FLYING HORSE NORTH FILING NO. 4
CONSTRUCTION DOCUMENTS
A TRACT OF LAND BEING A PORTION OF SECTION 30, TOWNSHIP 11 SOUTH,
RANGE 65 WEST OF THE 6TH P.M., AND A PORTION OF SECTION 31, TOWNSHIP 11
SOUTH, RANGE 65 WEST OF THE 6TH P.M.,
CITY OF COLORADO SPRINGS, COUNTY OF EL PASO, STATE OF COLORADO

As-Built Document
PE Approval by: Richard D. Lyon
(Stamp Appended on this Plan Sheet)
09/24/2026 10:43:30 AM

FLYING HORSE NORTH FILING 4
PRI #2, LLC.
EL PASO COUNTY, CO

SHEET
PND
31

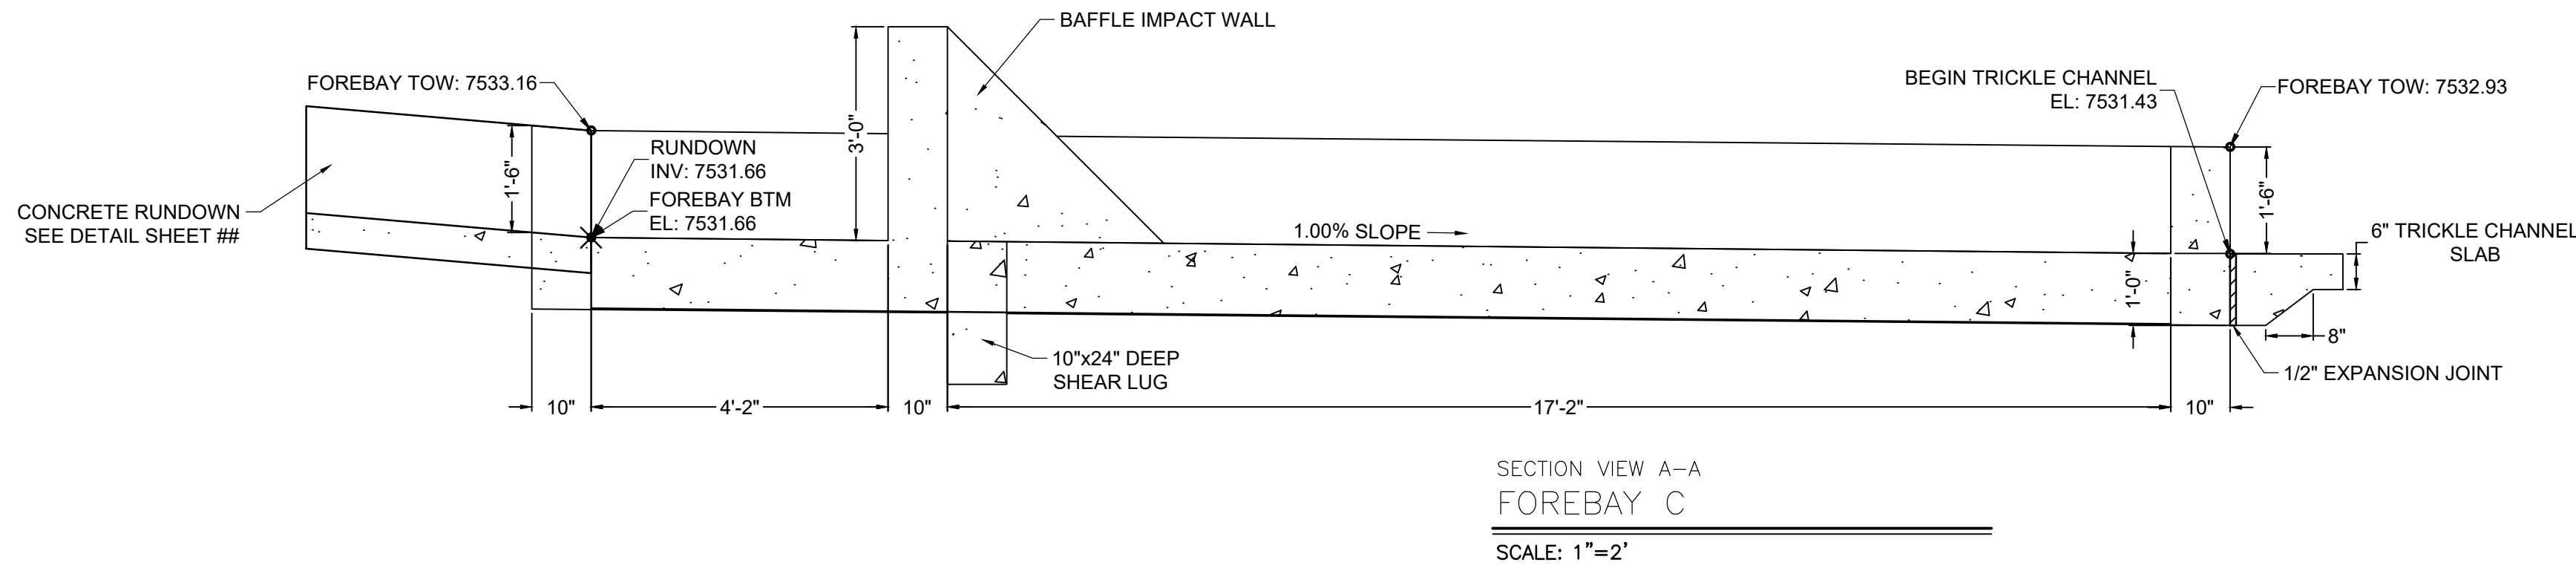
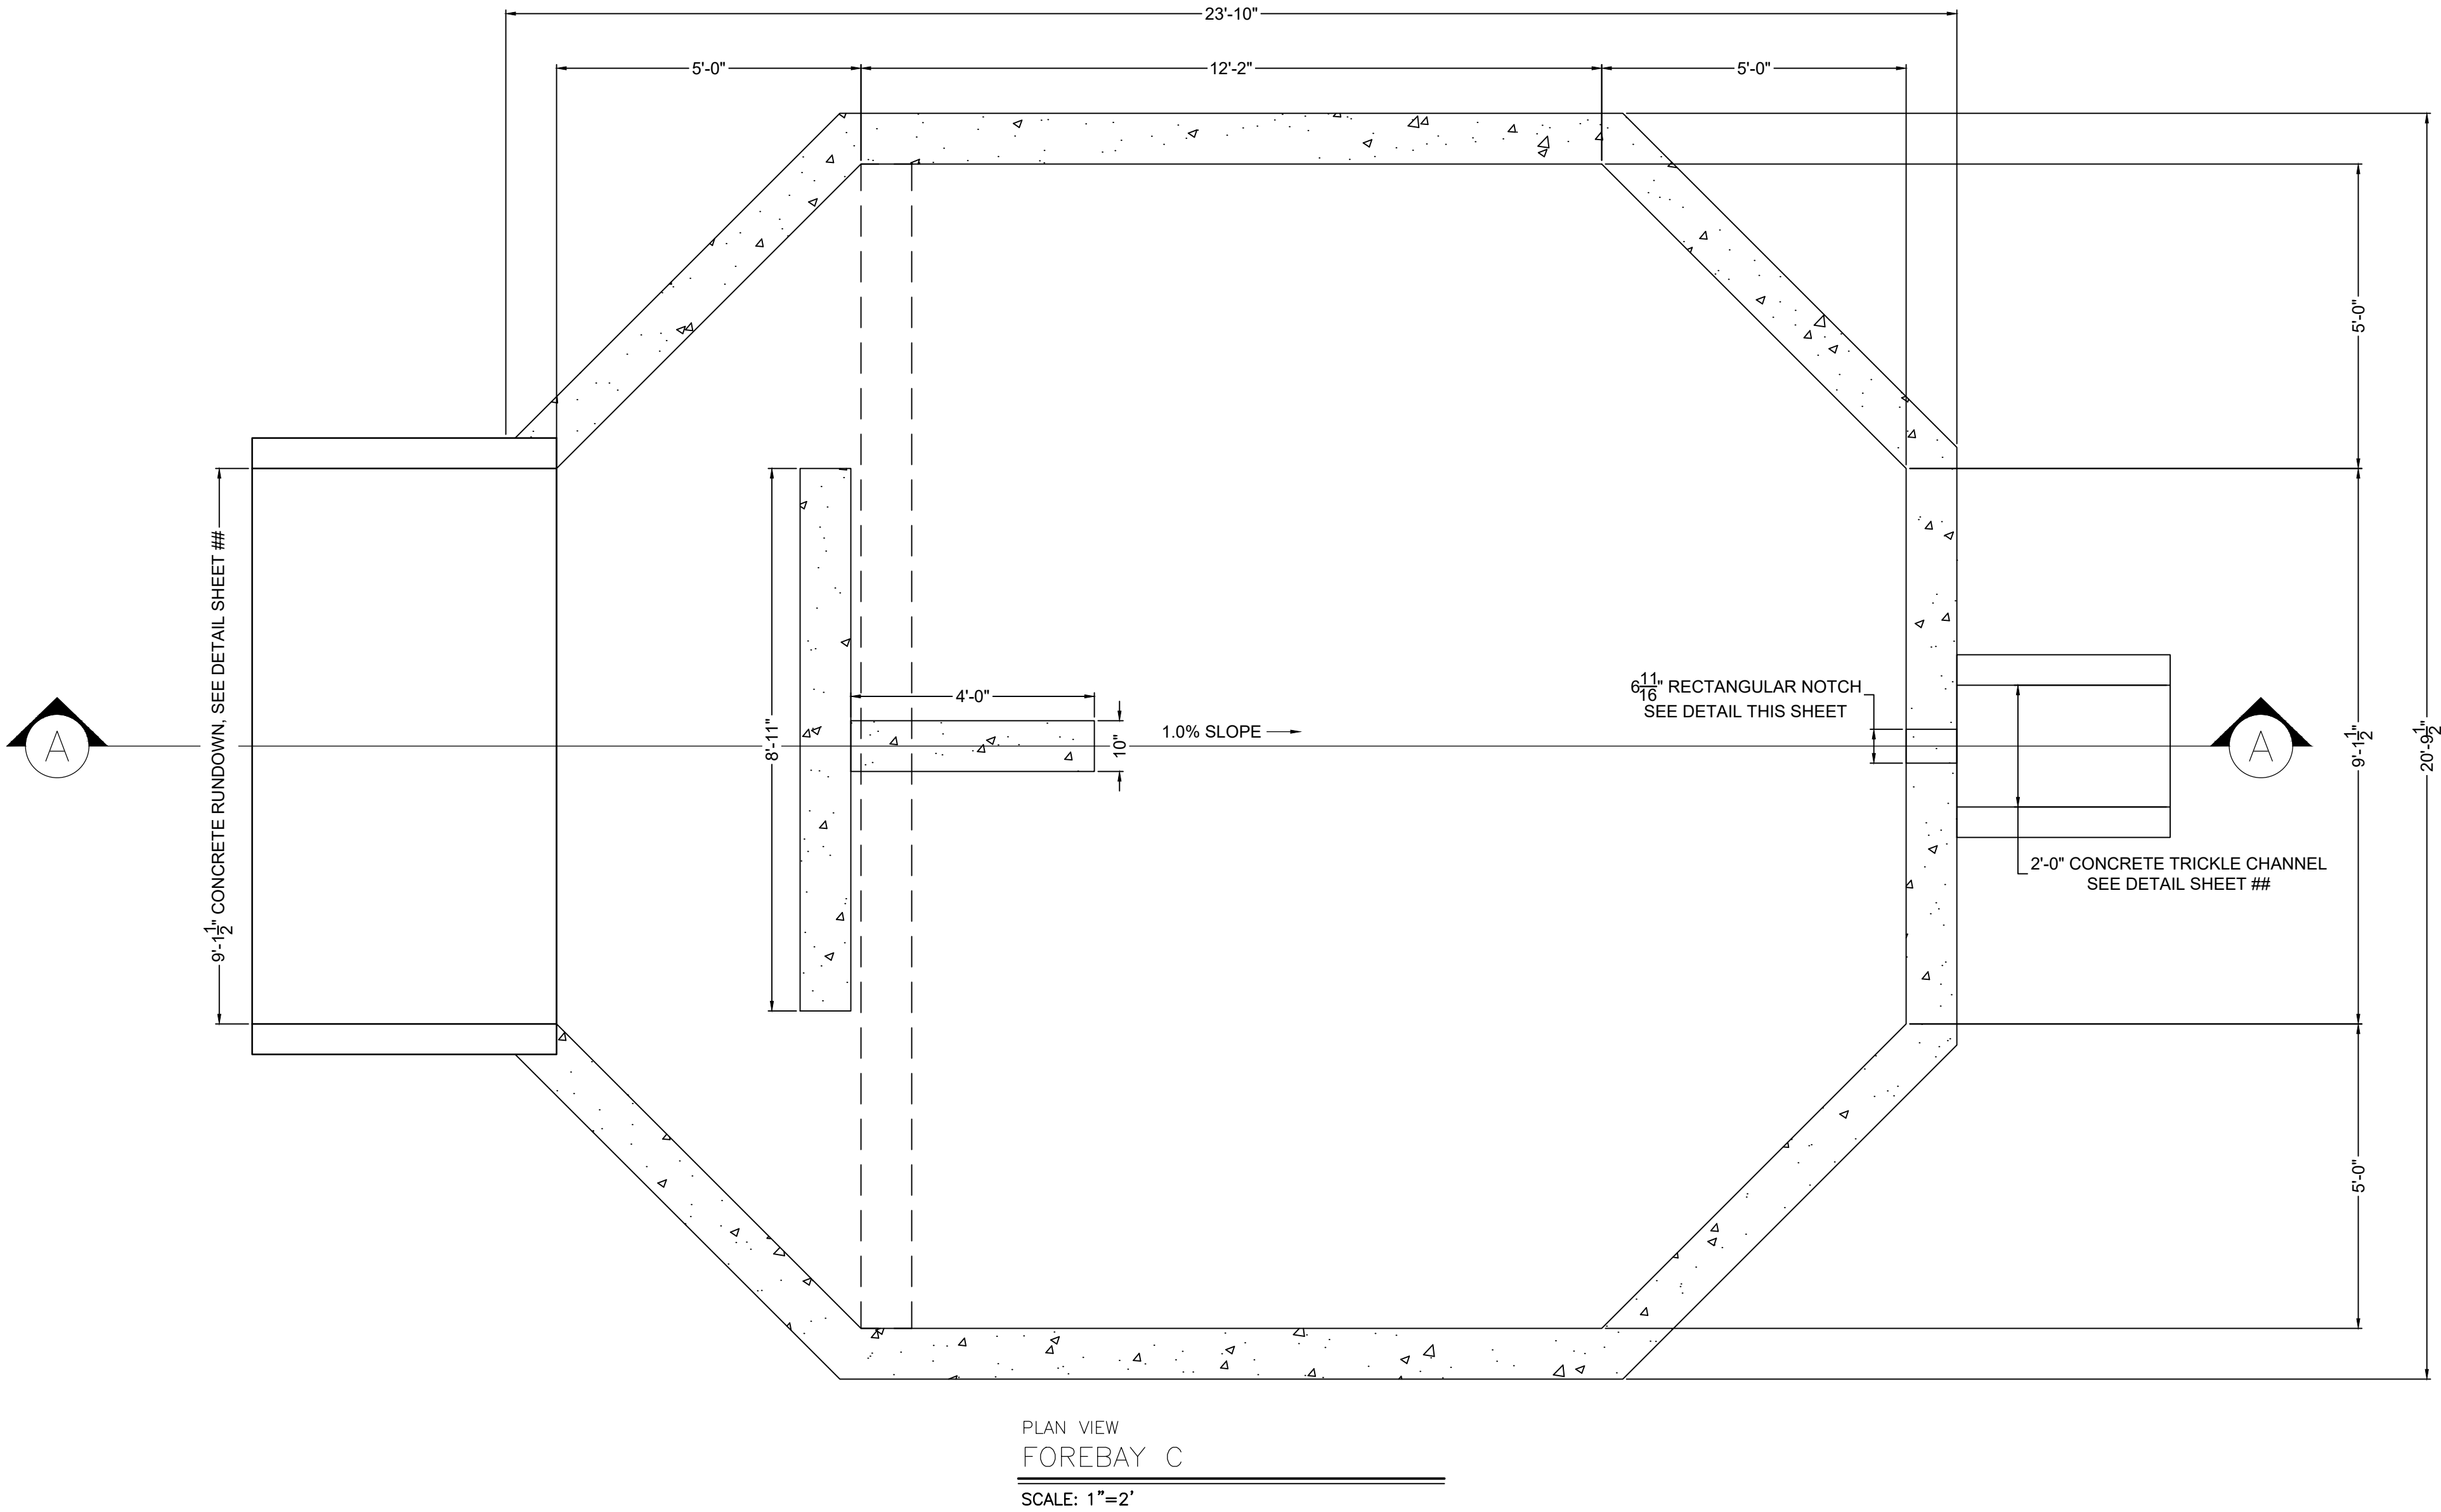
This sheet is missing your green "As-Built Document" text box and a 2026 PE stamp. Please add them.
